INTERNATIONAL CODE COUNCIL 2012 - 2014 CODE DEVELOPMENT CYCLE Group B (2013)

PROPOSED CHANGES TO THE 2013 EDITIONS OF THE

April 21st – April 30th, 2013
Sheraton Dallas Hotel
Dallas, TX

FIGURE R301.2(2)
SEISMIC DESIGN CATEGORIES—
SITE CLASS D

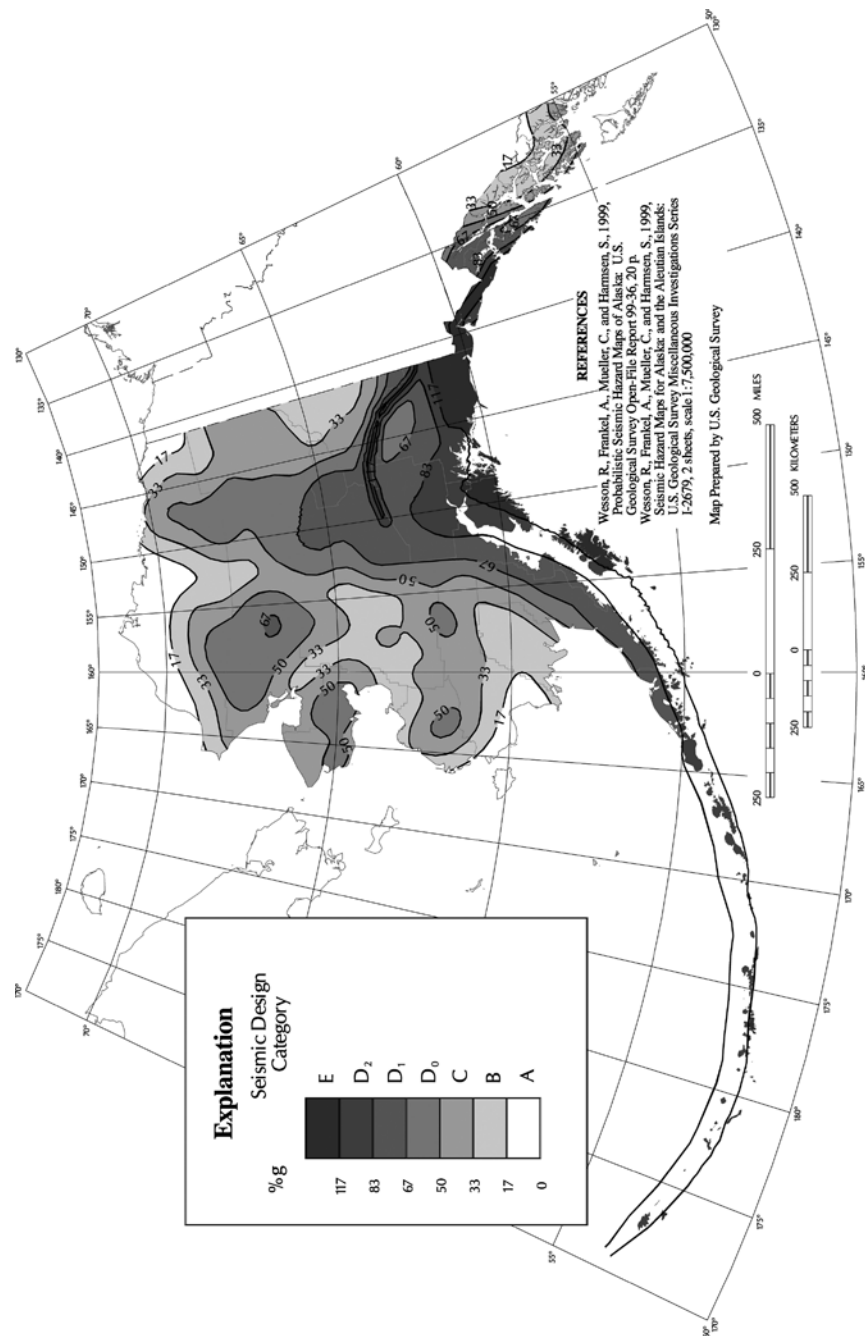
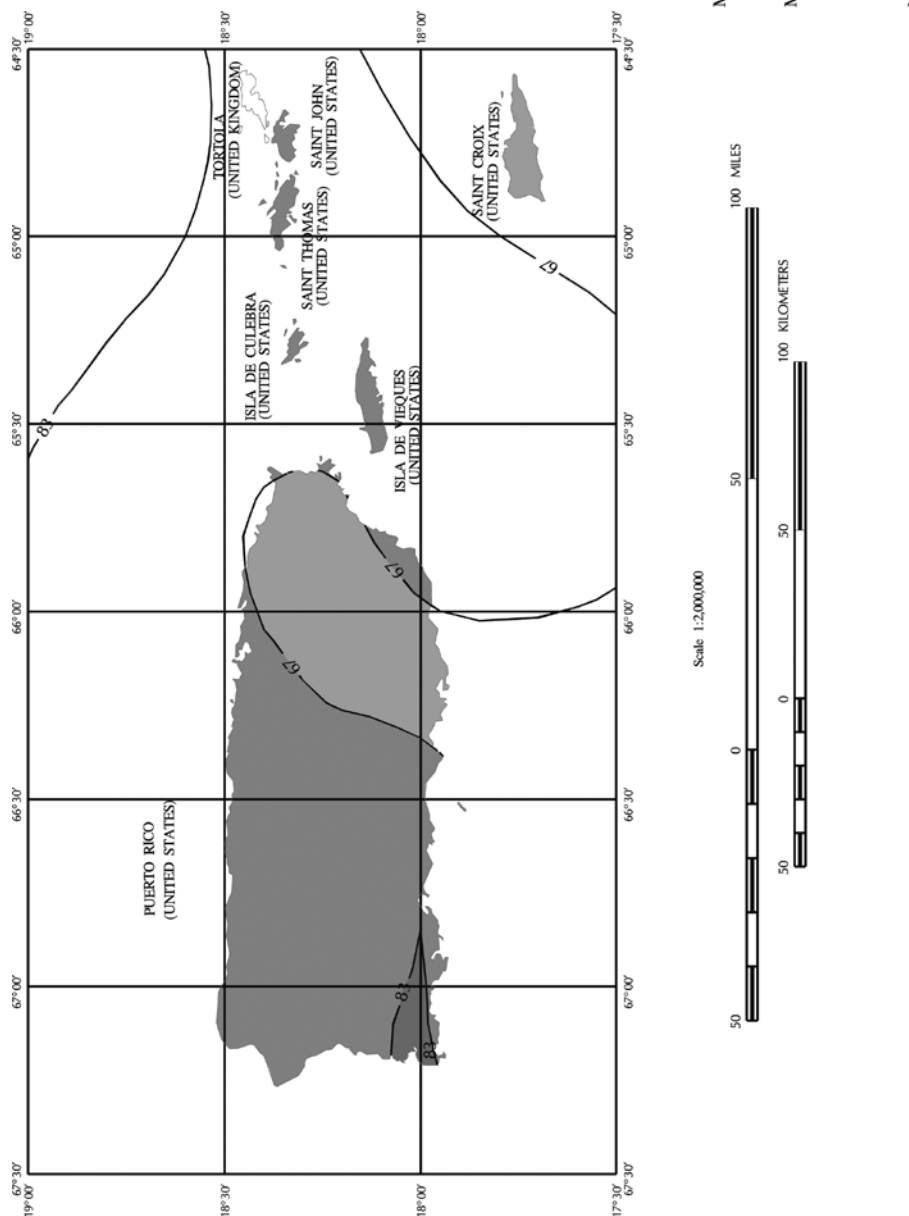
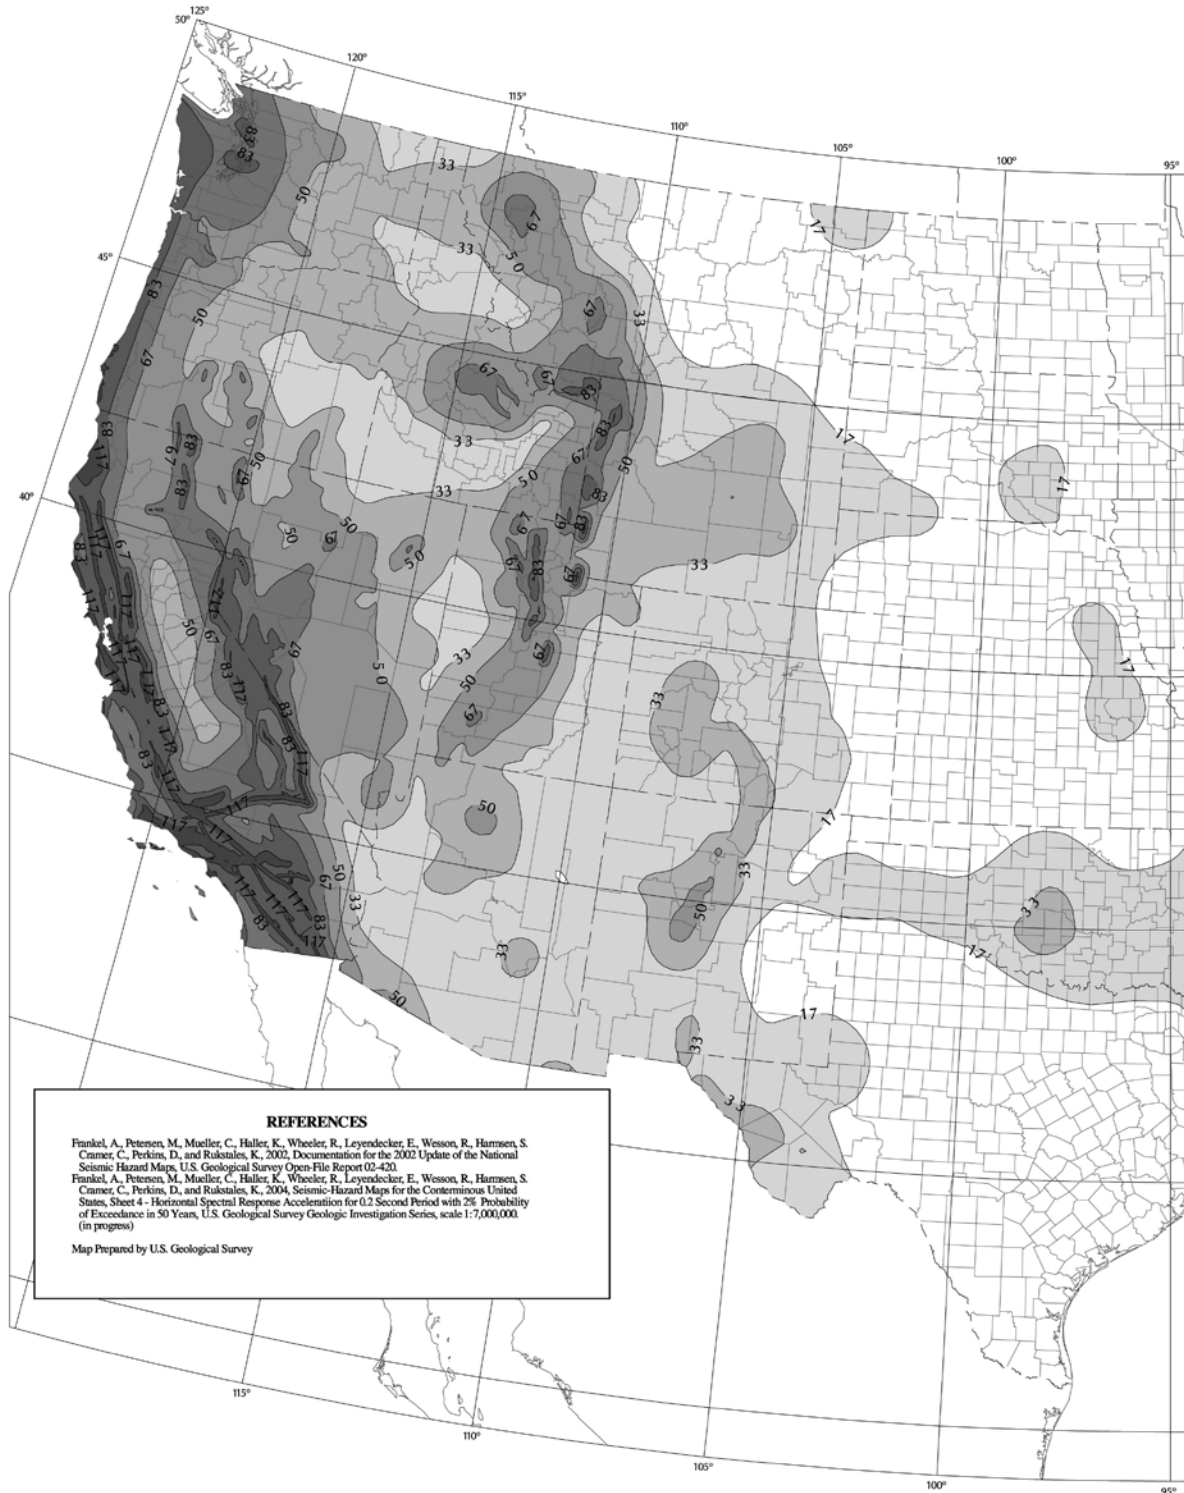
Delete and substitute as follows:

FIGURE R324.5
FOUNDATION TYPES

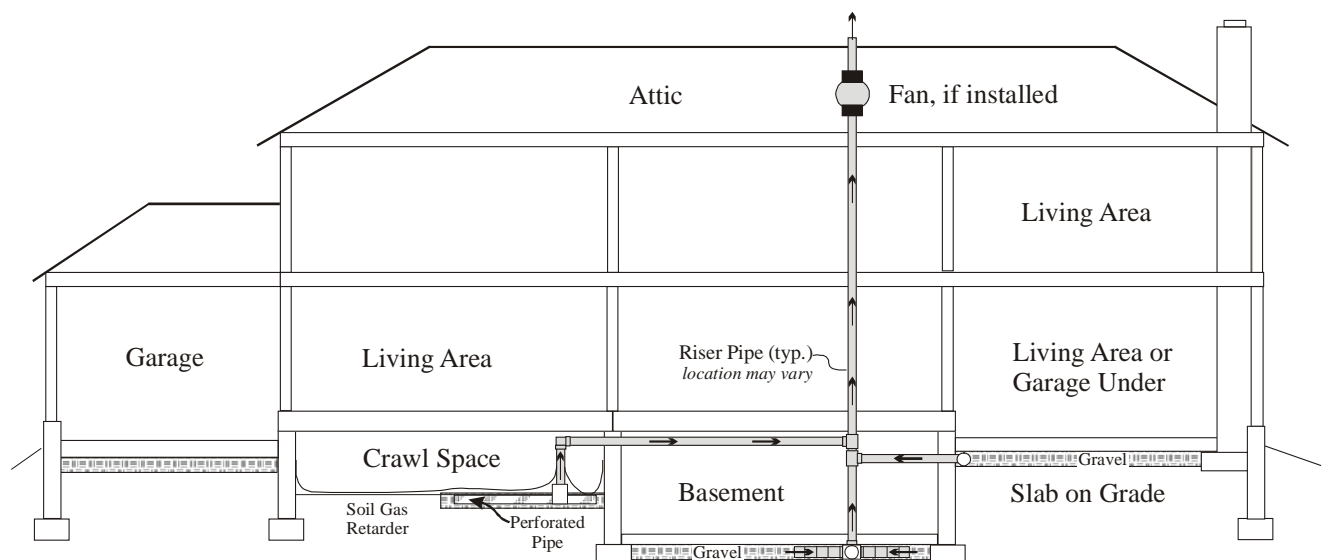
R324.5 Mitigation system rough-in required. The *Rough-In* installation of a *mitigation system* shall be required for all foundations and *combination foundations* types, including *crawl space*, *basement*, *slab-on-grade* and *slab-on-grade garage* located below a living area. The installation shall be in accordance with Sections R324.6 through R324.28. Figure R324.5 illustrates the four foundation types.

FIGURE R324.42
RADON POTENTIAL ZONES MAP
TABLE R324.42 EPA RADON ZONE 1 and 2 COUNTIES BY STATE

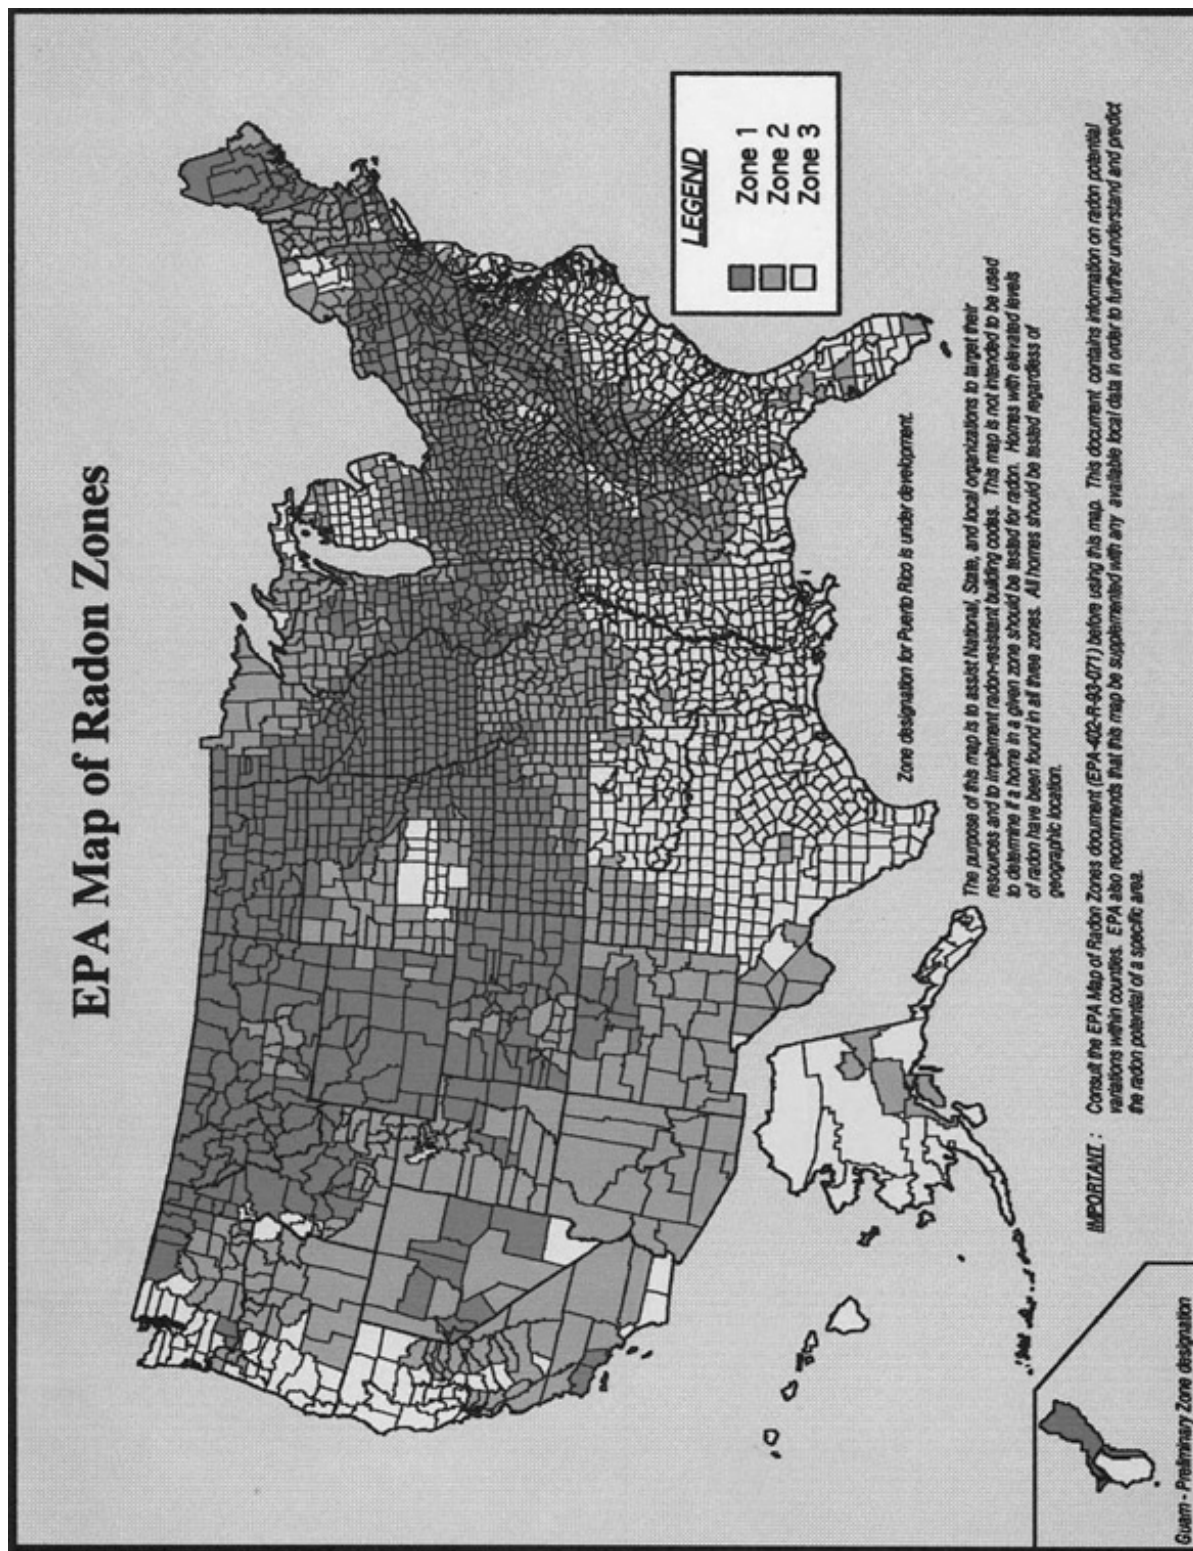
R324.42 EPA established zones. The *radon* potential of a building site shall be estimated from Figure R324.42 or from Table R324.42. Where state or local jurisdictions have published *radon* potential data, such data shall supersede the information in Figure R324.42 and Table R324.42.
